CLAREMONT BUSINESS PARK 2 FILING NO. 2

CONSTRUCTION PLANS

V1_CDs Redlines.pdf Markup Summary

Glenn Reese - EPC Stormwater (15)

TITLE SHEET

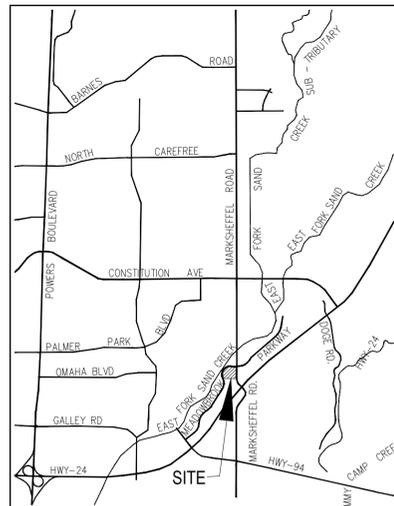
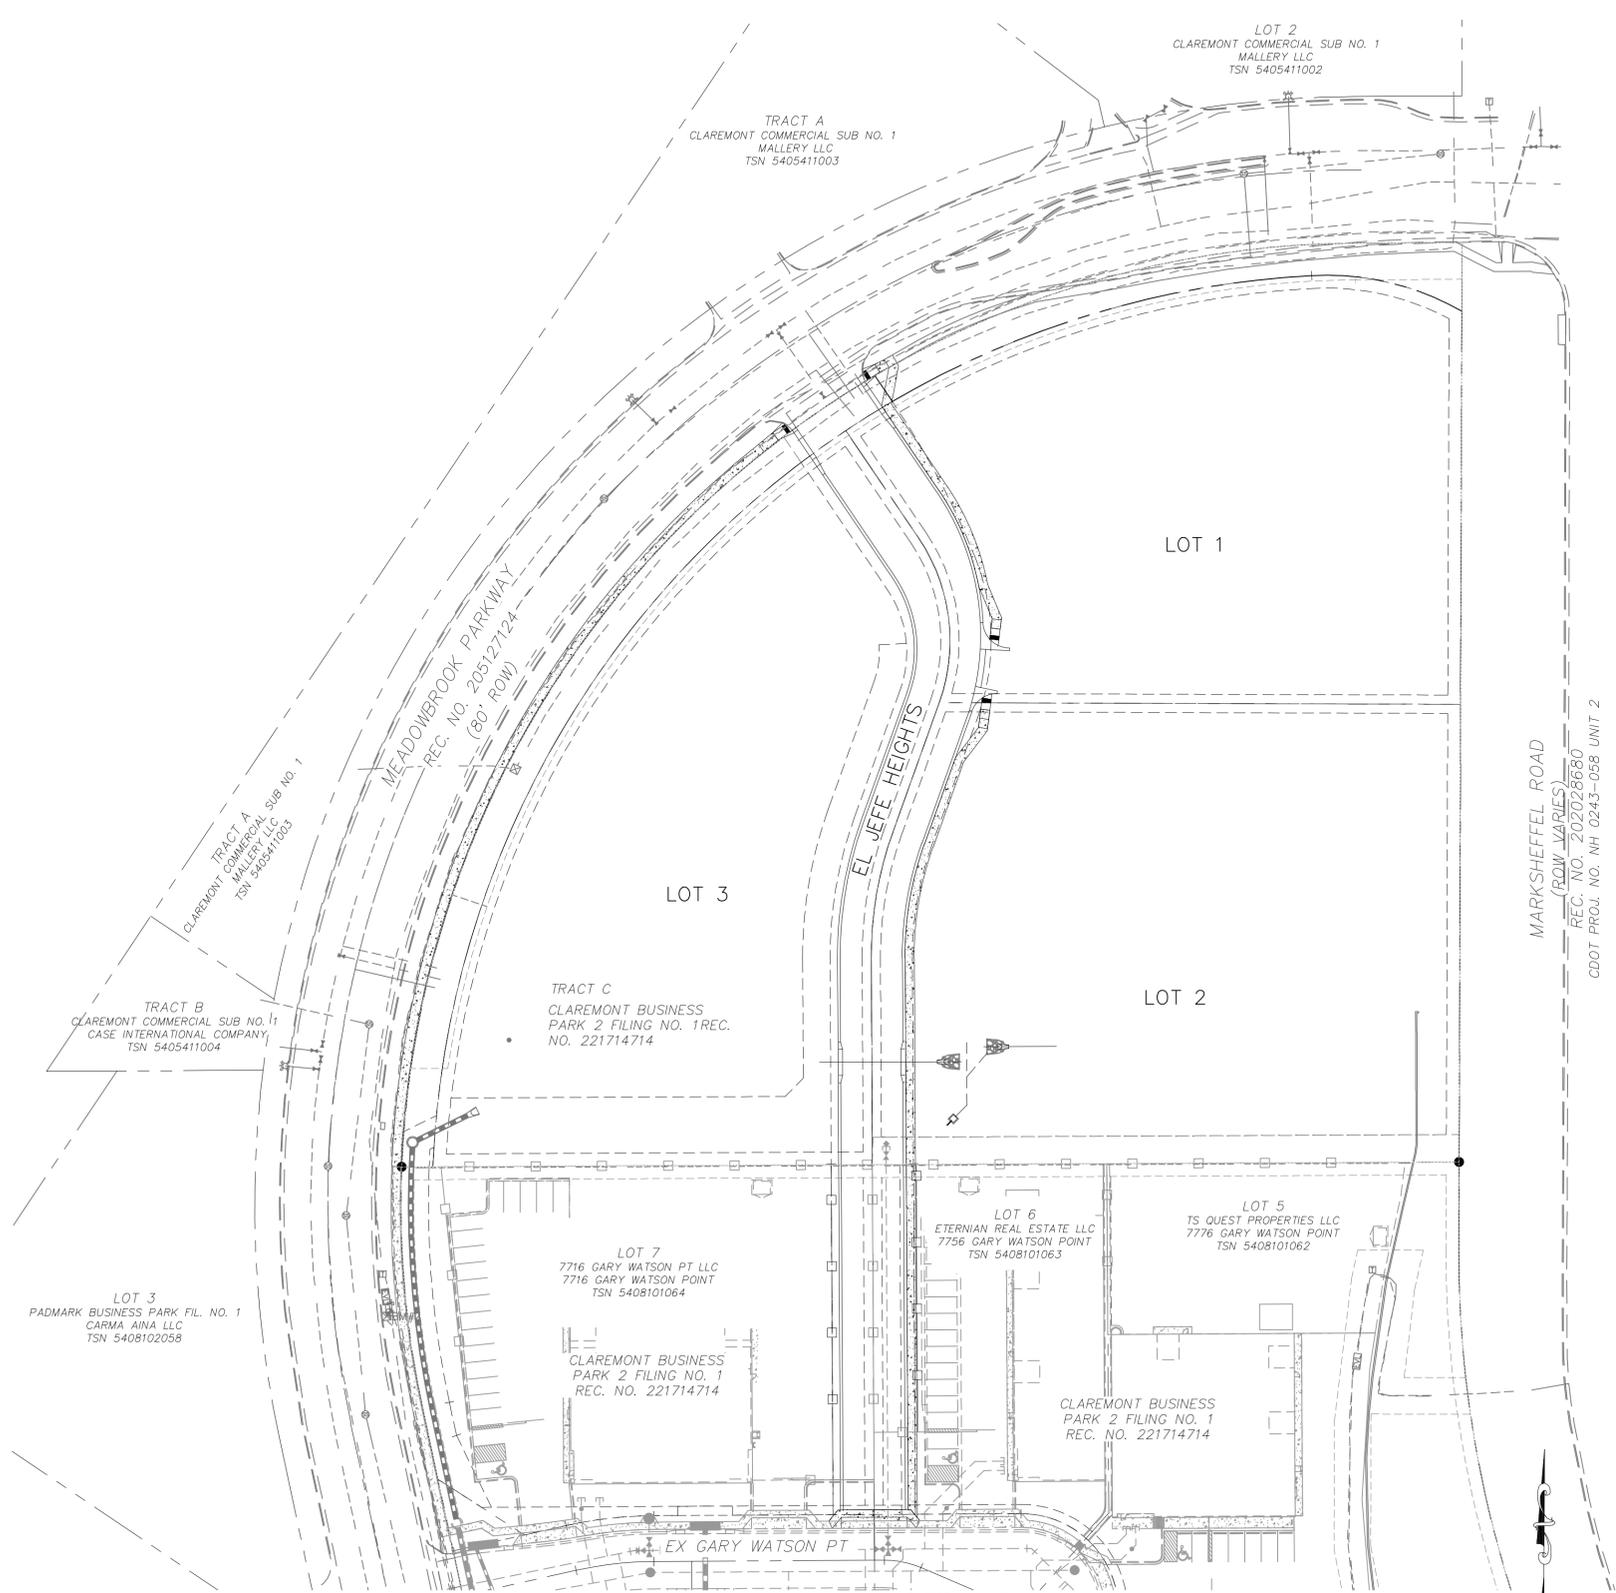
The last 3 sheets are pond details, not just the final 2.

The last 3 sheets are pond details, not just the final 2.

UPDATED

CONSTRUCTION STANDARD DETAILS

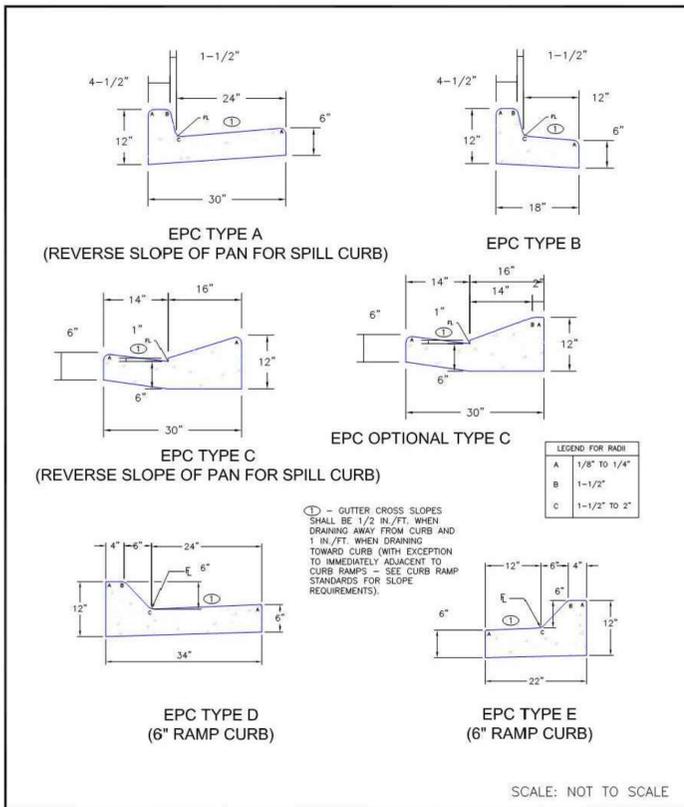
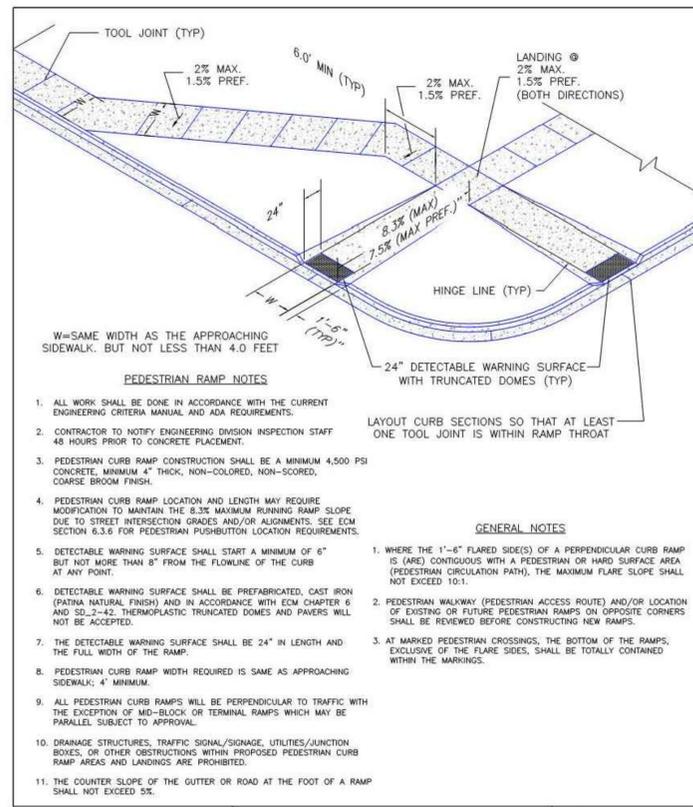
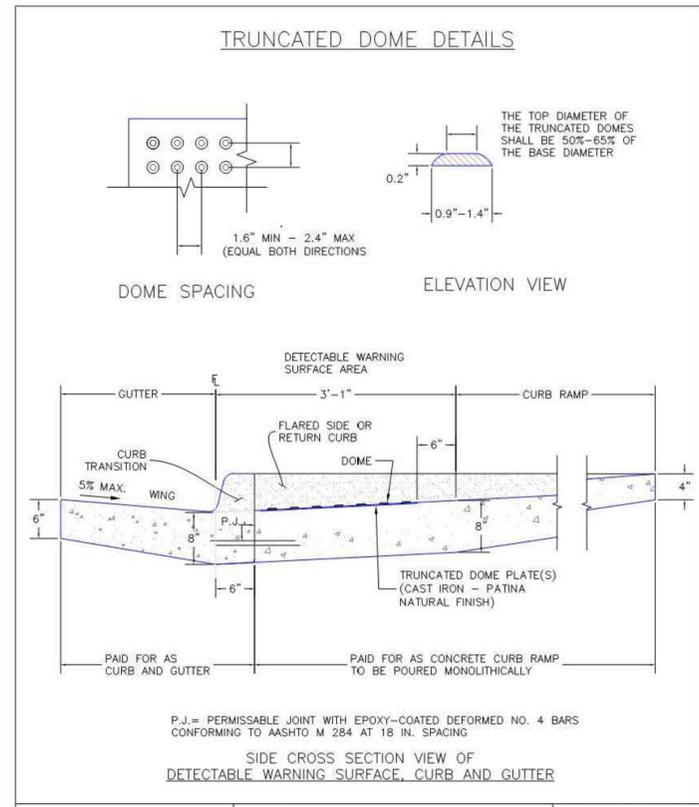
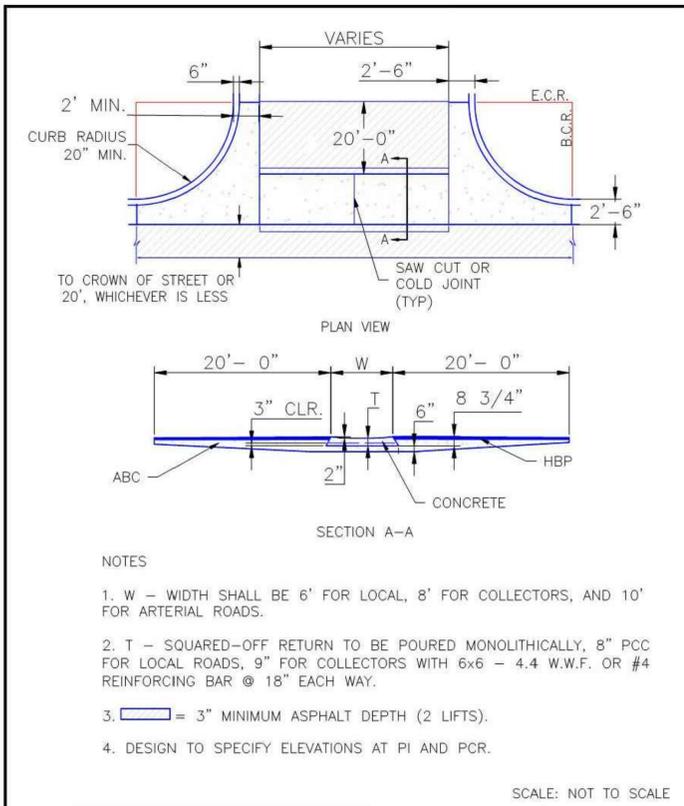
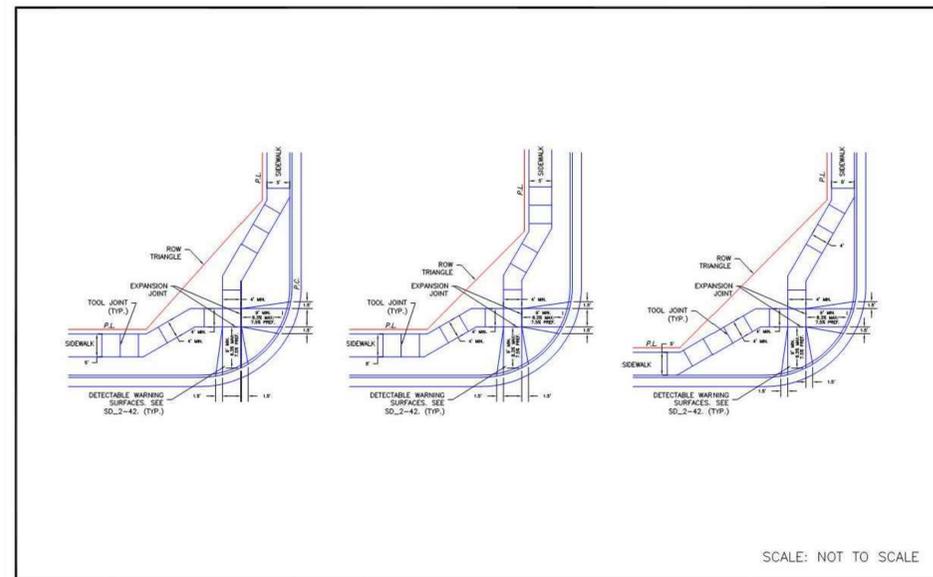
Please add El Paso County Standard Detail SD_2-24 Driveway Detail with Attached Sidewalk

ramps per SD 2-24. Per ECM Chapter 2 local roadways have attached sidewalks.

Smallest cross pan per dtl is 6' CROSS PAN CHANGED TO 6' WIDE

DETAIL ADDED

THE ACCESS ROADS ARE RETURNS RATHER THAN DRIVEWAYS, THEREFORE THE DESIGN OF THE RAMPS IS PER THE SD-2-40

**EL JEFE HEIGHTS
STA 1+00.00 - 7+95.49**

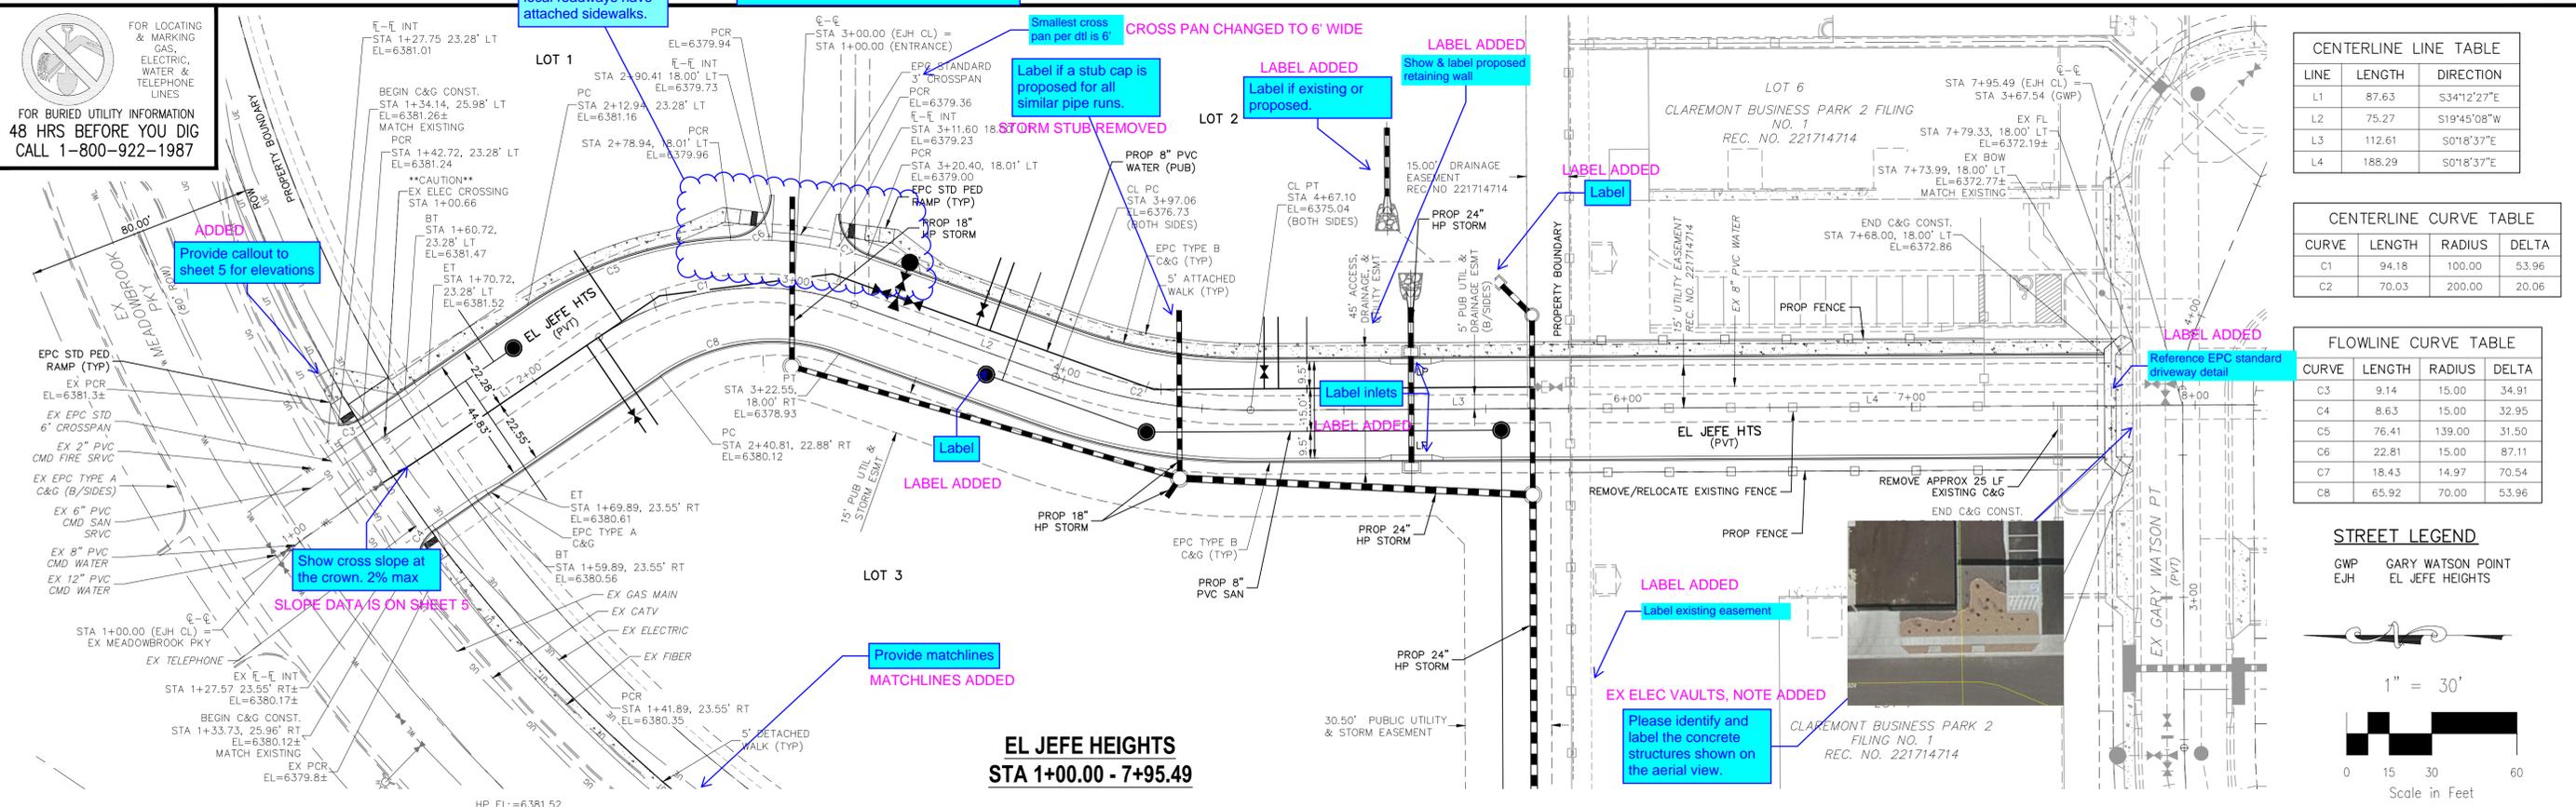
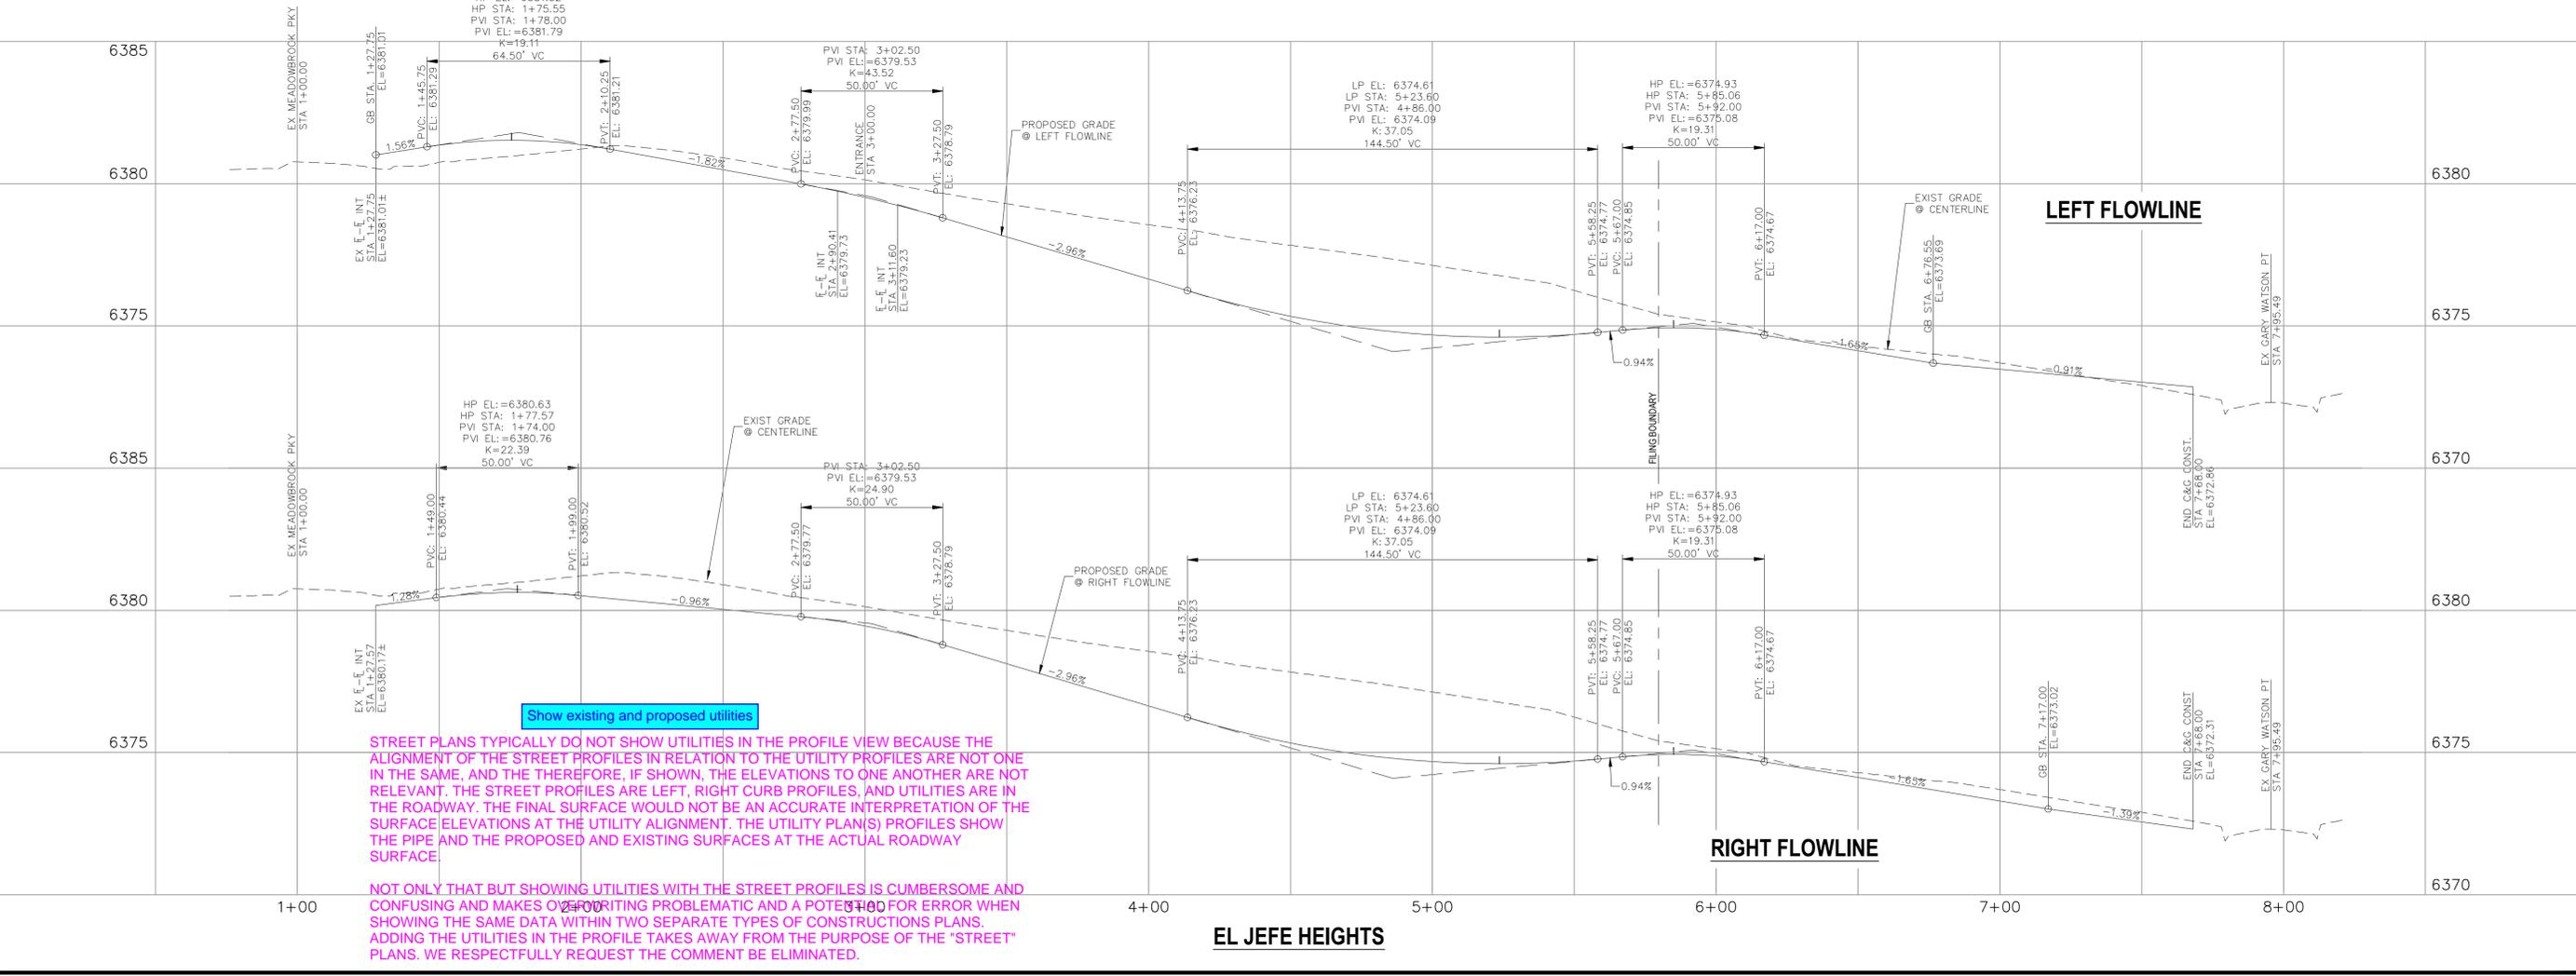
Show & label proposed retaining wall

Reference EPC standard driveway detail

Provide matchlines MATCHLINES ADDED

Please identify and label the concrete structures shown on the aerial view.

Show existing and proposed utilities

STREET PLANS TYPICALLY DO NOT SHOW UTILITIES IN THE PROFILE VIEW BECAUSE THE ALIGNMENT OF THE STREET PROFILES IN RELATION TO THE UTILITY PROFILES ARE NOT ONE IN THE SAME, AND THE THEREFORE, IF SHOWN, THE ELEVATIONS TO ONE ANOTHER ARE NOT RELEVANT. THE STREET PROFILES ARE LEFT, RIGHT CURB PROFILES, AND UTILITIES ARE IN THE ROADWAY. THE FINAL SURFACE WOULD NOT BE AN ACCURATE INTERPRETATION OF THE SURFACE ELEVATIONS AT THE UTILITY ALIGNMENT. THE UTILITY PLAN(S) PROFILES SHOW THE PIPE AND THE PROPOSED AND EXISTING SURFACES AT THE ACTUAL ROADWAY SURFACE

NOT ONLY THAT BUT SHOWING UTILITIES WITH THE STREET PROFILES IS CUMBERSOME AND CONFUSING AND MAKES OBTAINING PROBLEMATIC AND A POTENTIAL FOR ERROR WHEN SHOWING THE SAME DATA WITHIN TWO SEPARATE TYPES OF CONSTRUCTIONS PLANS. ADDING THE UTILITIES IN THE PROFILE TAKES AWAY FROM THE PURPOSE OF THE "STREET" PLANS. WE RESPECTFULLY REQUEST THE COMMENT BE ELIMINATED.
